Review of Meena Application Materials Received on May 17, 2023

This review is being prepared at the request of abutters William Bartoswicz (1 Blueberry Lane, Ossipee) and Tammy McPherson (5 Blueberry Lane, Ossipee). Geoscience Solutions LLC requested the most recent Meena application on May 16 and received immediate access to the documents. They represent the fourth in a sequence of submittals dating from March 2021. The following report documents environmental concerns related to the proposed building of a gas station at the Meena site, 41 Route 25 in Effingham NH.

Figure 1. SITE PLAN Legend and orthophoto (2015) of the Meena site showing new areas of RECONSTRUCTED PAVEMENT in red (from the SITE PLAN).

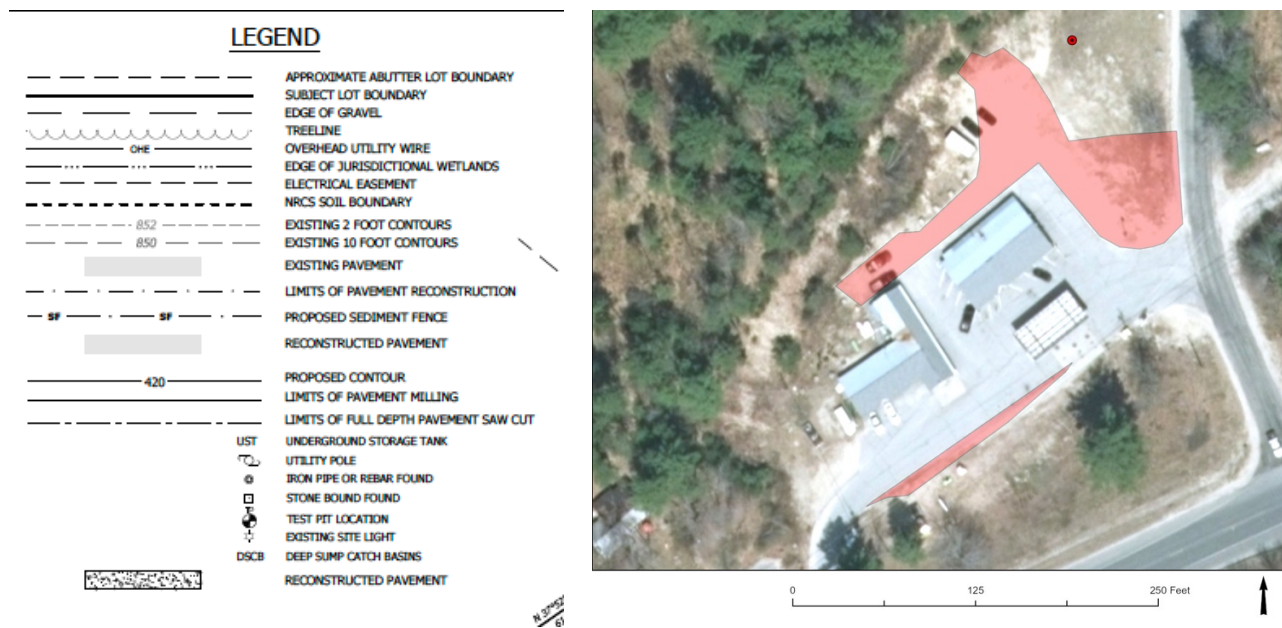
The plan (SITE PLAN) shows a large area of "Reconstructed Pavement" in areas that were not previously paved. Furthering the confusion, the legend shows two different

symbols both labelled as RECONSTRUCTED PAVEMENT with one of the two also identical to the symbol for EXISTING PAVEMENT (Figure 1). Clearly some of the RECONSTRUCTED PAVEMENT marks the replacement of pre-existing pavement that has been removed during construction. But RECONSTRUCTED PAVEMENT is also shown covering a large area towards the back of the property, as well as a small area towards the front, that are currently unpaved, but have been used for parking etc. (Figure 1). Is this area to be paved? If so, it would represent an increase of approximately 13,500 ft² of pavement. There could be good reasons to do this. It is always better to have cars parked on a paved surface in a critical recharge area as potentially contaminated runoff can then be directed to the stormwater treatment facility. However, the stormwater system must be able to handle the additional runoff and the proposed stormwater system appears to be inadequate even without this new area being added. (See *HydroCad Modeling section of this report*).

Figure 2. Section of the STORMWATER MANAGEMENT PLAN showing the drain line going from the diesel pad directly to the infiltration basin. Note that there is no reference to the required canopy on this plan.

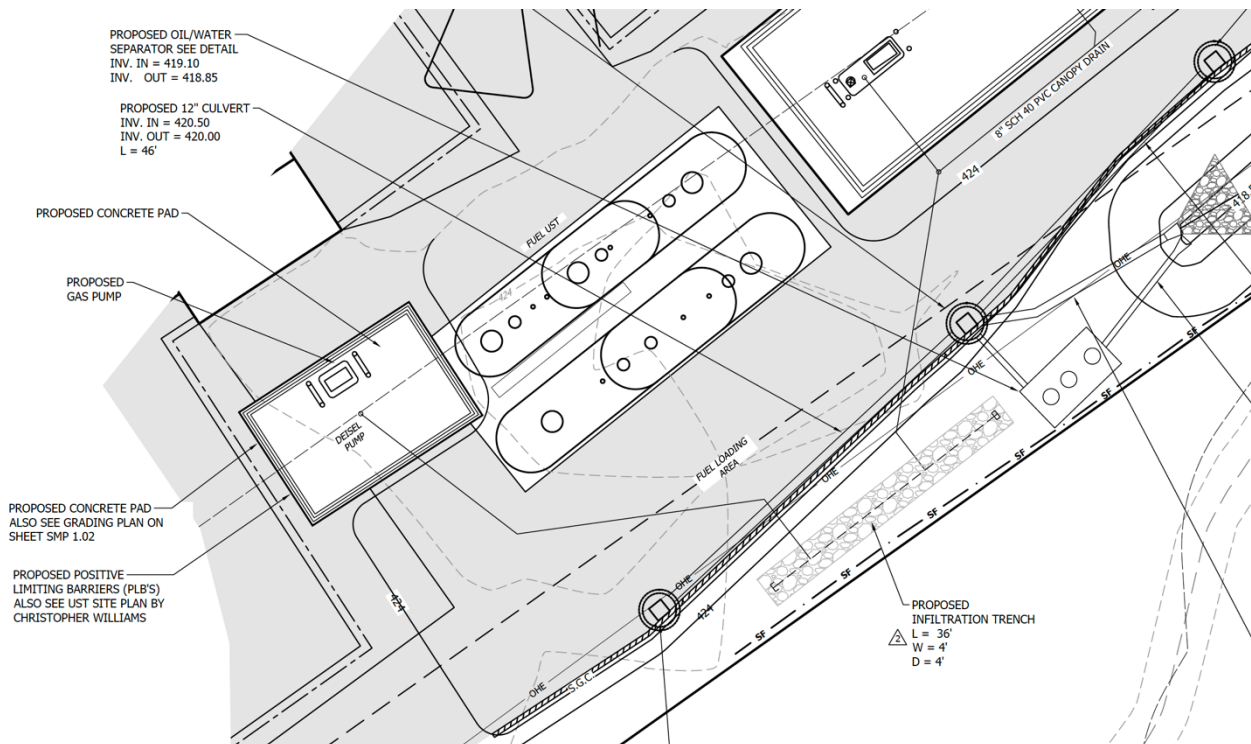
Item (6) of the STORMWATER MANAGEMENT GUIDELINES in the STORMWATER MANAGEMENT PLAN clearly states “The gas station is considered a HIGH LOAD AREA and the following design methods are required”. The very first item in the list is “Canopies over the fueling areas”. There is a pre-existing canopy over the site for the gas pumps, but there is currently nothing in the area of the new diesel pump. None of the design documents show a plan for a canopy to be built over the diesel pumps (none on any of the previous plan submittals either). A drain line is shown going from the center of the diesel fueling pad to the infiltration basin (Figure 2) and in at least one drawing it is labeled as coming from the canopy over the diesel pumps. Without a clear

design drawing for the canopy, it is impossible to know if this drain is adequate or if the canopy will ever be built. The plan should be modified to show the actual design drawings of the canopy and they should be reviewed by the Planning Board's consulting engineer.

Critically, if no canopy is built, these plans could be misinterpreted to mean that a drain line should go directly from the fueling pad to the infiltration basin. This would be a recipe for disaster as any spills would be infiltrated directly to groundwater with no treatment at a distance less than 250 ft from a public water supply well. Any plan for this site that does not include plans for a canopy over the diesel fueling area must be rejected.

Figure 4. POST DEVELOPMENT DRAINAGE PLAN showing the sub-catchments and principal drainage system components. Note S7 (diesel pump pad) is drained directly to the infiltration basin.

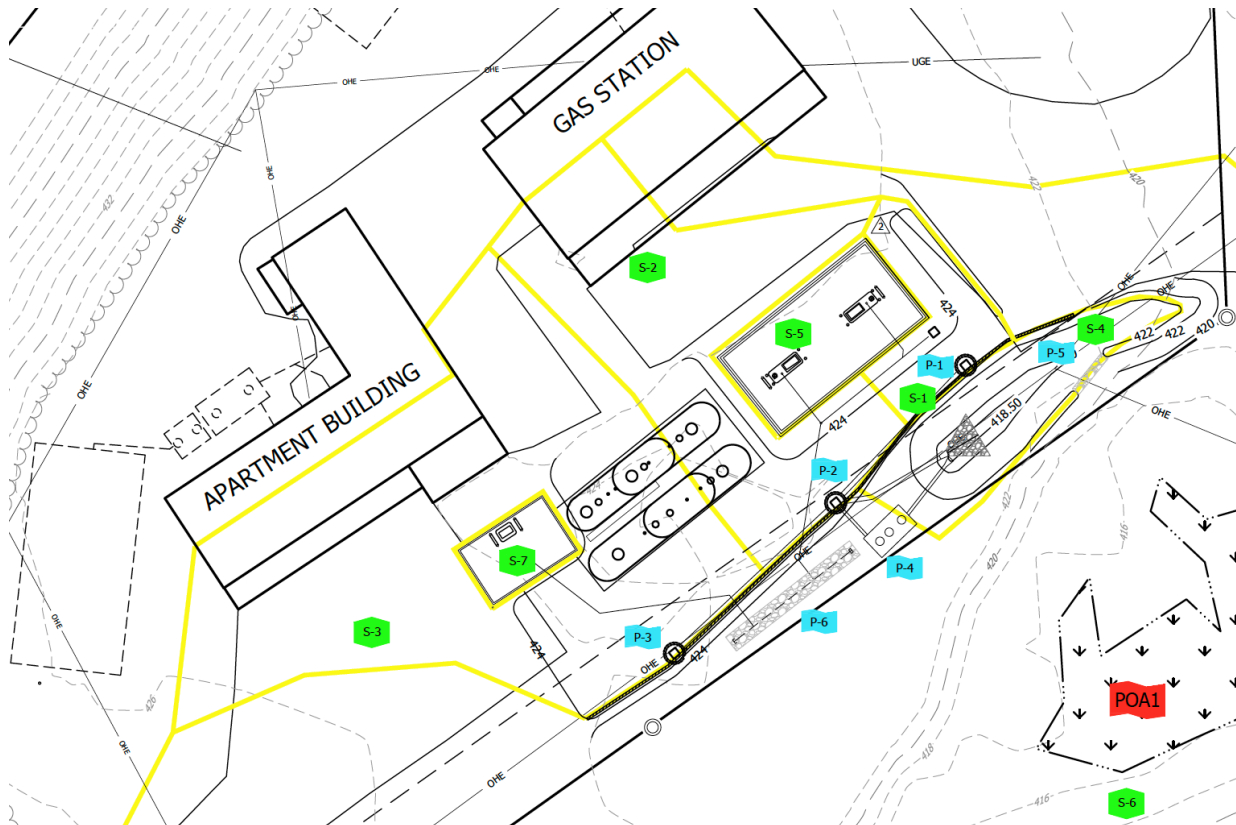
- The sub-catchment divides do not conform well to the contour lines. The lines demarcating the sub-catchments should cross the contour lines at right angles (90°). For example, the S-3 catchment line just below the S-3 symbol should cross the 426 ft contour at a right angle and not at the angle shown. The effect of this is that the estimate for the S-3 catchment area is smaller than it actually is and the amount of runoff would be more than what was modeled.
- There is also a catchment boundary shown going between the apartment building and the store (across the paved parking lot). While this could be valid there is no elevation data presented to support this and in fact the LiDAR data shows that the pavement is all sloped towards the USTs (Figure 5).

- The report only presents detailed analysis for flows within the stormwater system for the 10-year (4.29 in) storm event, but that analysis shows that the system was unable to handle runoff from an event of this size. The model shows that the water level in the bioretention basin gets more than 2.5 ft higher than the upstream oil/water separator. AND it is higher than the outlet inverts further upstream in Deep Sump Catch Basin 2. This backflow situation would likely force all the oil collected in the oil/water separator back out of the system. It would also flood the overflow pipe that goes directly from the Deep Sump Catch Basin 2 to the Bioretention basin. Since this happened during the 10-year storm it will also happen for the 25-year and 50-year storms. This, coupled with the likely underestimation of sub-catchment sizes draining into these structures shows that the drainage system needs a complete redesign.

Figure 5a. Line of profile used to extract LiDAR elevations to determine if there is a catchment divide in the area between the apartment building and the store.

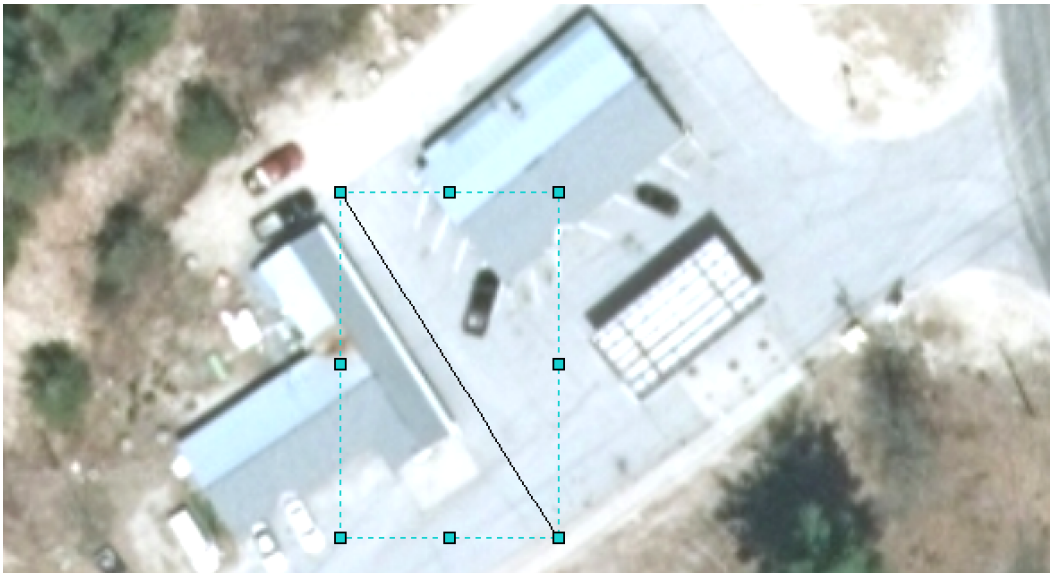
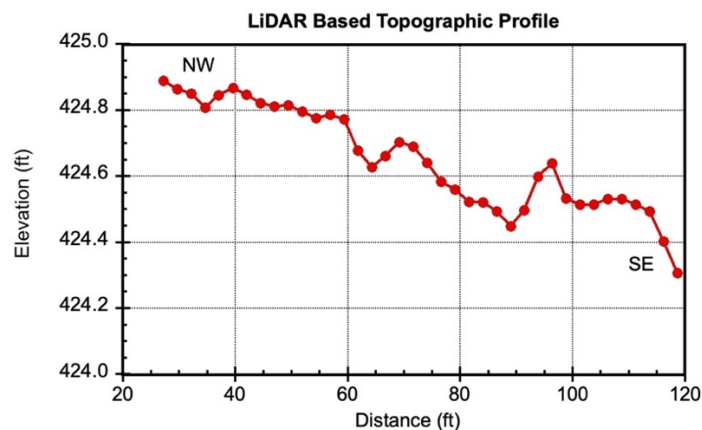
The net effect is again that the catchment size is under estimated so that the modeled stormwater is less than the amount that would actually move through the stormwater system.
